### TECHNICAL BULLETIN

[Issue No.] FA-A-0165 [Title] External appearance changes of the QCPU-A (A mode) [Date of Issue] April 2014 [Relevant Models] Q02CPU-A, Q02HCPU-A, Q06HCPU-A [Page] 1/2

Thank you for your continued support of Mitsubishi programmable controllers, MELSEC-Q series. This bulletin announces the external appearance changes of the QCPU-A (A mode).

(1) Lid closed state

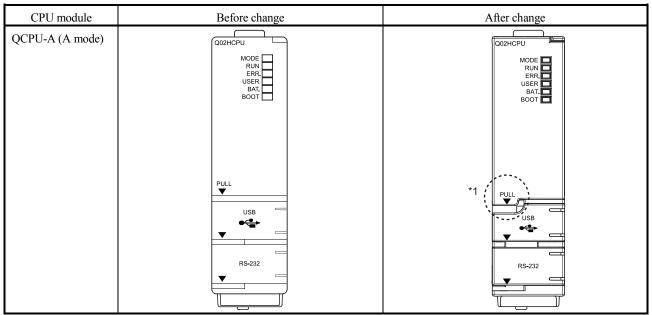
The shape of the lid is changed (figure below<sup>\*1</sup>).

### (2) Lid opened state

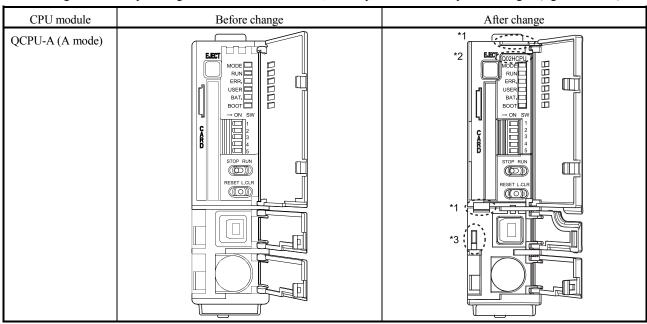
The slits are added (figure below<sup>\*1</sup>).

The model name is additionally displayed (figure below\*2).

Along with the shape change of the USB connector lid, the shape of the lid lock part is changed (figure below\*3).
